CITY OF GEARHART

CITY OF GEARHART PLANNING COMMISSION
From: Carole Connell, City Planner
Re: Approval request for an Off-Street Parking Variance

CITY STAFF REPORT
September 7, 2017

City File # 17-012 Dollar General

Sheet Title:
LANDSCAPE PLAN
Sheet Number:
L1.01

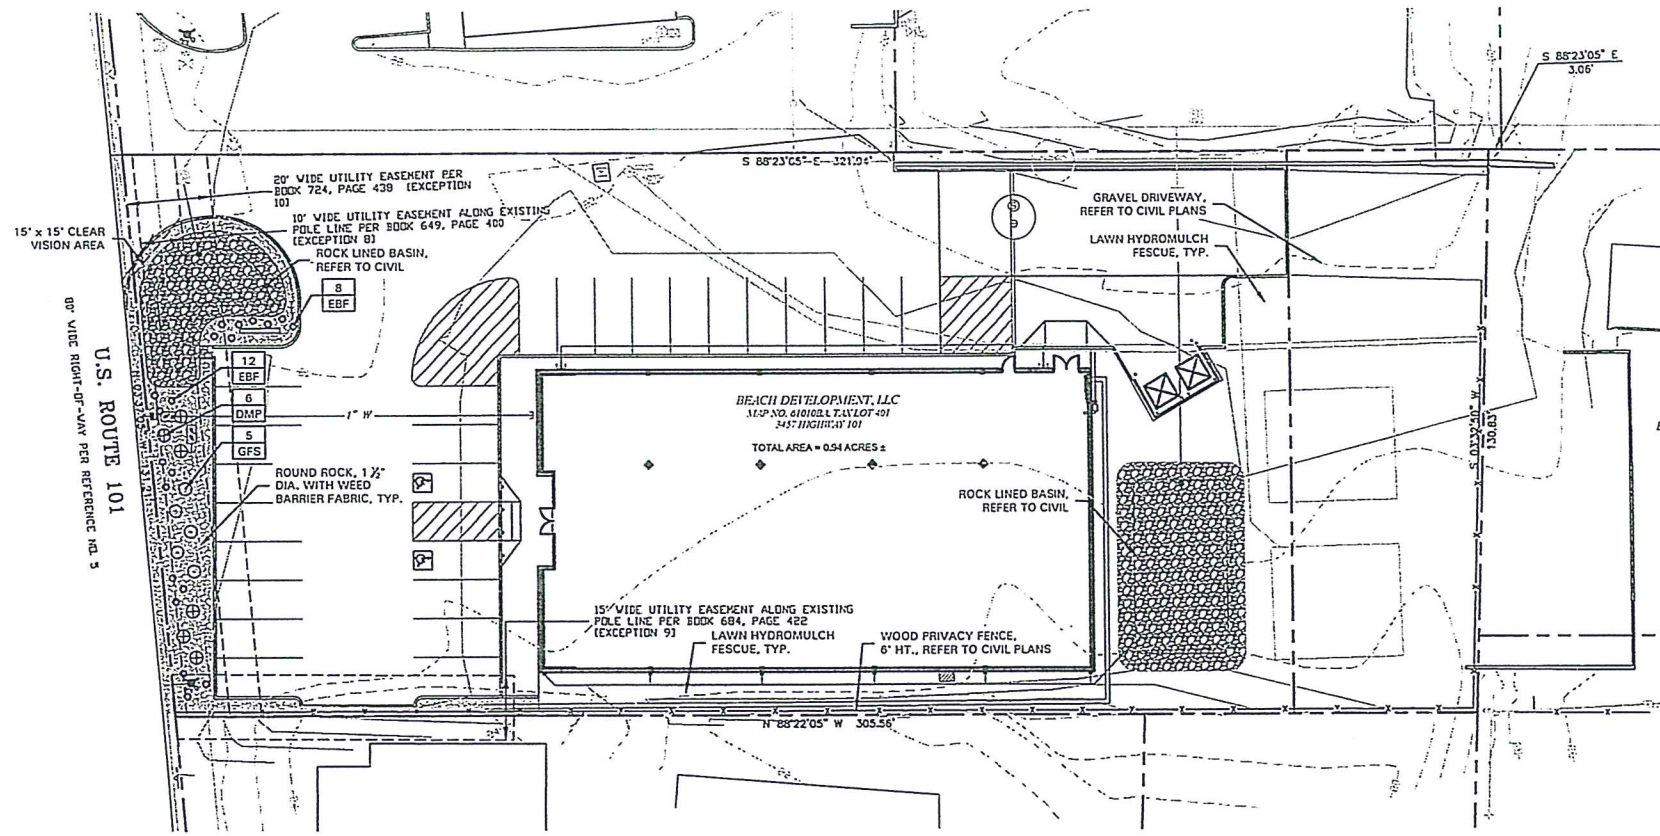
FINDINGS: The applicant submitted a landscape plan on the highway frontage. The groundcover is rock with an underlying fabric weed barrier. The plant materials include two-foot high shrubs and grasses (5spirea, 20fescue) and 6 dwarf mugo pine trees. On the south property line adjoining the building a lawn and fescue strip and a wood privacy fence are proposed.

FINDINGS: *Spirea betulifolia* is a native spring flowering shrub 3 feet high, and should replace the proposed *spirea glauca*. *Festuca californica* is a native fescue grass, forms a tight clump of blue gray leaves 2 – 3 feet high and should replace the smaller *festuca bumalda*.. *Mugo* pines are native trees of Spain, Central Europe and the Balkans. The pines should be replaced with a native deciduous street tree.

1. An acceptable plan for adequate water supply and water pressure to the site has not been provided;
2. A site storm water drainage plan that effectively controls storm water from the site has not been provided;
3. A septic system plan has not been provided;
4. Utility and access easements have not been defined;
5. An outdoor lighting plan has not been provided;
6. The landscape plan lacks imagination and aesthetics. A revised plan is recommended utilizing native plants and native deciduous trees.
